## PSEUDO-CHANGE REQUEST

33.878 CR CRNum rev - 0.0.3 Current version:

<b>Title:</b>	Correction of figures		
<b>Source:</b>	Huawei		
<b>Work item code:</b>	Early IMS	<b>Date:</b>	5/11/2004
<b>Category:</b>		<b>Release:</b>	
	Use <u>one</u> of the following categories: <b>F</b> (correction) <b>A</b> (corresponds to a correction in an earlier release) <b>B</b> (addition of feature), <b>C</b> (functional modification of feature) <b>D</b> (editorial modification) Detailed explanations of the above categories can be found in 3GPP <a href="#">TR 21.900</a> .		Use <u>one</u> of the following releases: <b>Ph2</b> (GSM Phase 2) <b>R96</b> (Release 1996) <b>R97</b> (Release 1997) <b>R98</b> (Release 1998) <b>R99</b> (Release 1999) <b>Rel-4</b> (Release 4) <b>Rel-5</b> (Release 5) <b>Rel-6</b> (Release 6) <b>Rel-7</b> (Release 7)

Figure 1: Message sequence for early IMS security showing a successful registration

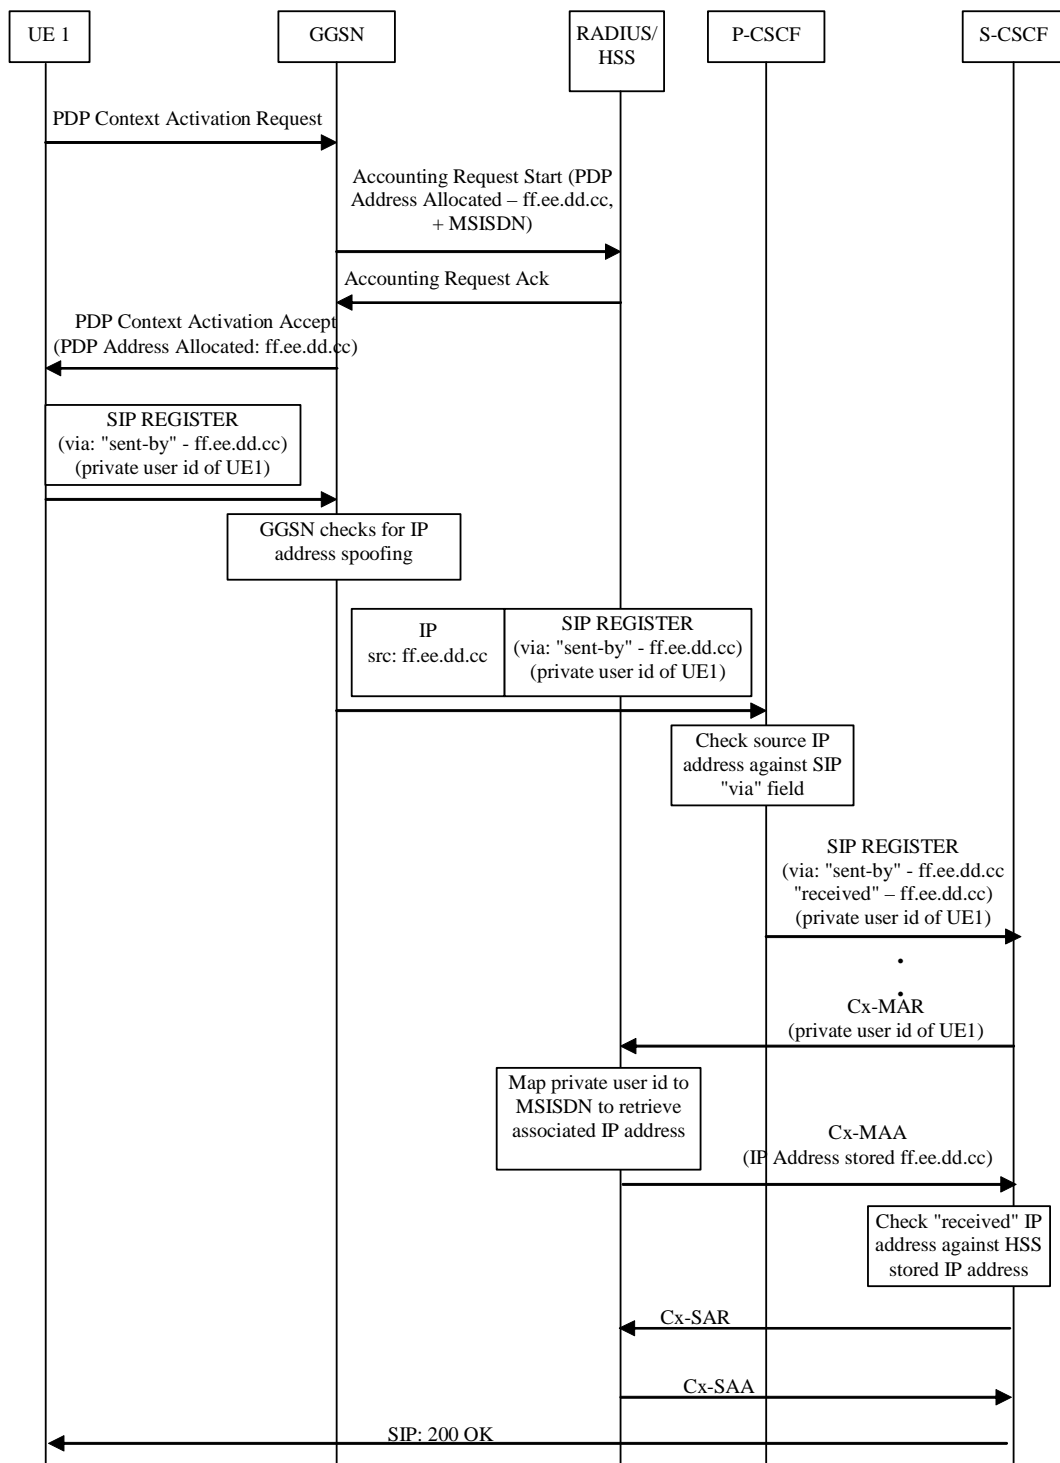
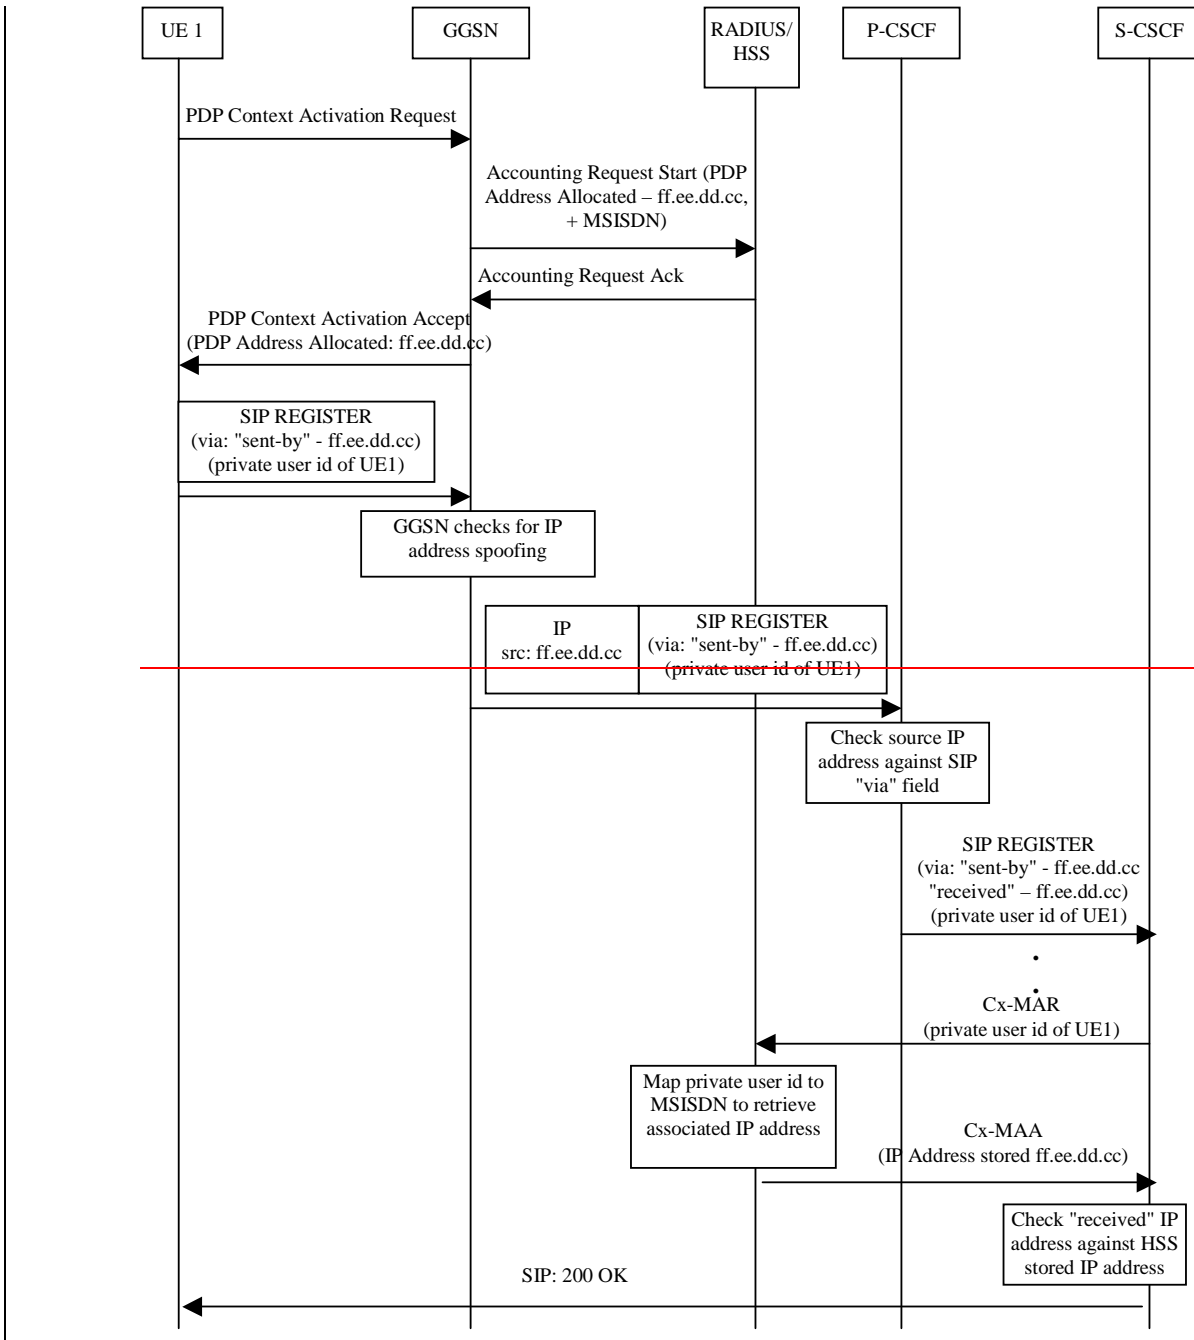
<b>Reason for change:</b>	In the figures of registration, there is not notification of registration status to the HSS after the authentication, then HSS don't know the result of authentication. it can not record the UE as registered when successful authentication, or delete the pending flag when unsuccessful authentication.
<b>Summary of change:</b>	Adding registration status notification to HSS in registration procedure
<b>Consequences if not approved:</b>	The registration procedure is incomplete
